**Tweed Shire Council comments on the proposed North Byron
Parklands Cultural Event Site (SSD 8169) and modification of the
Concept Plan (MP09_0028 Mod 5)**

I refer to your email of 27 July 2018 inviting Council's comments in relation to the proponent's Response to Submissions for the proposed SSD and Concept Plan Mod 5 at the North Byron Parklands Cultural Event Site, Yelgun. The following matters are raised for the Department's consideration.

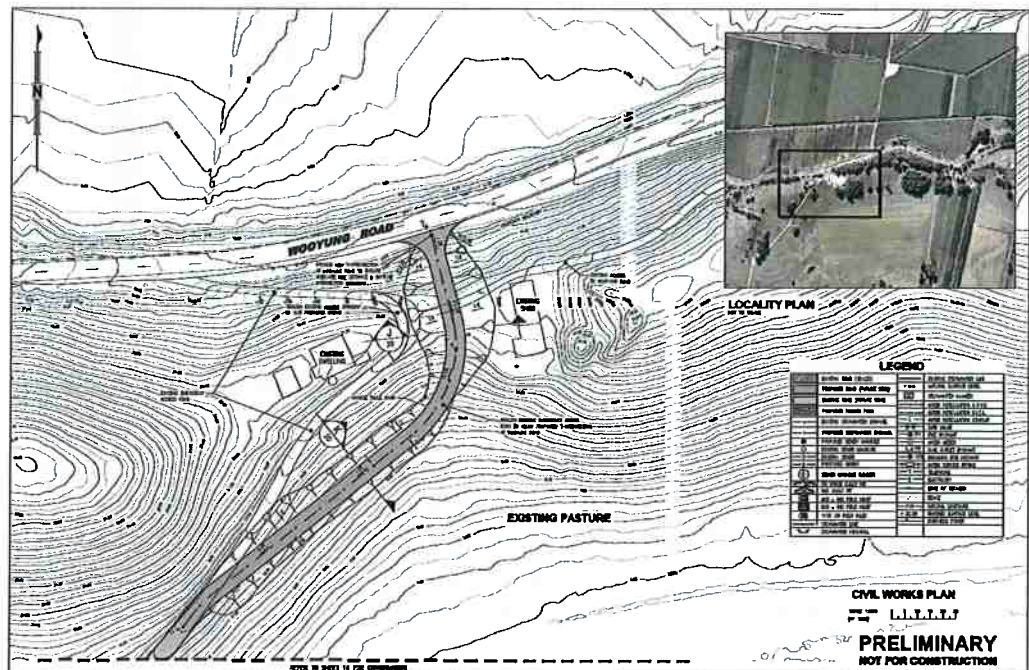
- a. Appendix C of the EIS indicates that the Gate E access is proposed to be constructed approximately 100m east of the existing access (see below). It would appear that the new access location is due to the existing emergency access being deficient in sight distance (as per the Austroads Guidelines). Limited detail has been provided for the realignment of the existing road. Further detail is requested with regard to long sections, proposed road widening (of Wooyung Road) or dimensions.

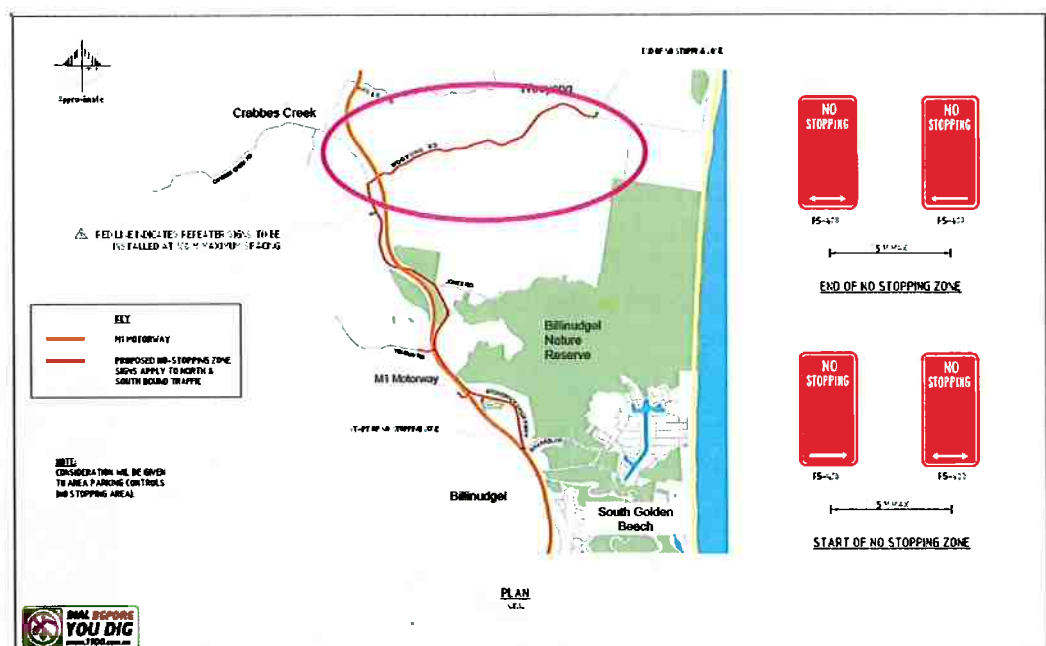
- d. Appendix P of the EIS incorporates a No Stopping Plan which includes Wooyung Road (highlighted below in pink). As noted previously, Tweed Shire Council does not support the installation of "No Stopping" signs on Wooyung Road, as this results in a resource issue in the enforcement of the signs. It is requested that the Traffic Control Plans be amended accordingly.
